Technical Service Bulletin (TSB)

Telematics Box Module (TBM) Firmware Over The Air (FOTA) Software Updating from 5.39 to 5.65

REFERENCE:	TSB: 08-219-25 REV. A GROUP: 08 - Electrical	Date:	December 10, 2025	REVISION:	08-219-25
VEHICLES AFFECTED:	2022 - 2023 (DT) RAM 1500 Pickup 2022 - 2023 (DJ) RAM 2500 Pickup 2022 - 2023 (D2) RAM 3500 Pickup 2022 - 2023 (DD) RAM 3500 Cab Chassis 2022 - 2023 (DF) RAM 3500 10K LB Chassis This bulletin applies to vehicles built on and after May 12, 2023 (MDH 0512XX) and on and before August 31, 2023 (MDH 0831XX) equipped with a Global Telematics Box Module (Sales Code RDG).			MARKET APPLICABILITY: ☒ NA☐ MEA ☐ SA☐ IAP ☐ EE☐ CH NOTE: This bulletin applies to the North America market.	
CUSTOMER SYMPTOM:	**Customers must experience a Malfunction Indicator Lamp (MIL) illumination and the vehicle must exhibit/set the following Diagnostic Trouble Code (DTC): - B2206-00 - Current VIN Missing / Mismatch.** Customers may experience the following: **SOS Unavailable message pops up on radio during a remote start event due to TBM DTC B2206-00.**

Fig. 2

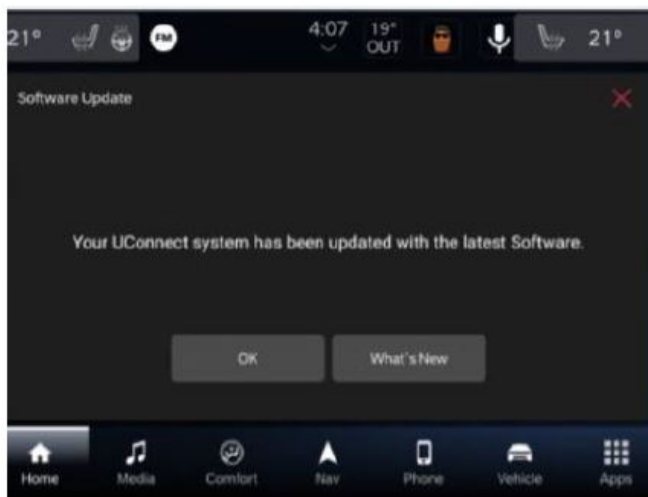
3. Upon completion of update, the radio will display a confirmation message [Fig. 2](#).
